Access Compliance Report

Public Rights-of-Way

Intersection ID: 28305	Main Street: COMMUNITY HOUSE RD	Cross Street: TAMARACK DR	Location:	N
ADA ID: EA5E982B9D4A	Ramp Type: Combination1Diag	Initial Pass/Fail: Fail	Overall Compliance: No	Severity Score: 0

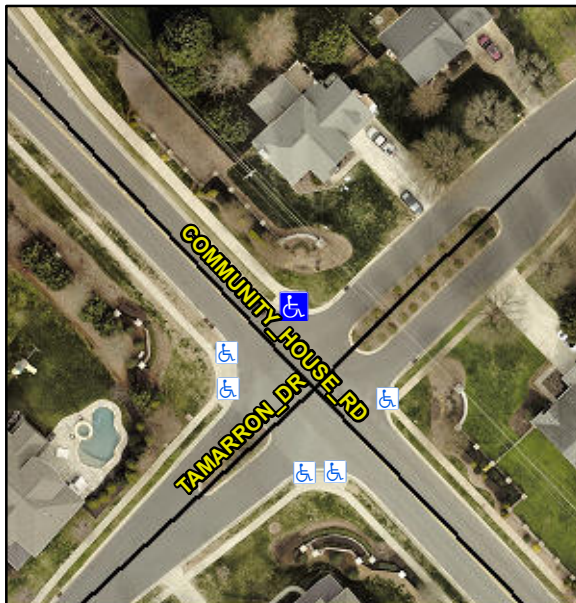
RP < 5 %, CURB WIDTH 44.0

R304.5.1, R304.5.3

Compliance	Description	Data	Compliance	Description	Data
N/A	Ramp Length LT (in)	41.0	N/A	Ramp Length RT (in)	48.0
Yes	Ramp Width LT (in)	70.0	Yes	Ramp Width RT (in)	71.0
Yes	Ramp Slope LT (%)	7.0	Yes	Ramp Slope RT (%)	7.1
Yes	Ramp XSlope LT (%)	1.5	No	Ramp XSlope RT (%)	2.8
N/A	Ramp Length (in)	48.0	Yes	Ramp Slope (%)	4.7
No	Ramp Width (in)	47.0	Yes	Ramp XSlope (%)	0.5
N/A	Flare Type LT	N/A	N/A	Flare Type RT	N/A
N/A	Flare Slope LT (%)	N/A	N/A	Flare Slope RT (%)	N/A
N/A	Flare Traversable LT?	N/A	N/A	Flare Traversable RT?	N/A
N/A	Landing Length (in)	N/A	N/A	DWS Provided?	N/A
N/A	Landing Width (in)	N/A	N/A	DWS Contrast?	N/A
N/A	Landing Slope (%)	N/A	N/A	DWS Length (in)	N/A
N/A	Landing X Slope (%)	N/A	N/A	DWS Full Width?	N/A
N/A	Landing Curb? (Y/N)	N/A	N/A	DWS Offset (in)	N/A
N/A	Shared Landing?	N/A			
N/A	Gutter Ponding?	N/A	N/A	Gutter Slope (%)	N/A
N/A	Gutter Lip Ht (in)	N/A	N/A	Gutter X Slope (%)	N/A
N/A	Painted X Walk1?	No	N/A	Painted X Walk2?	No

Remove & Replace Curb Ramp With Two New Directional Ramps or Equivalent.
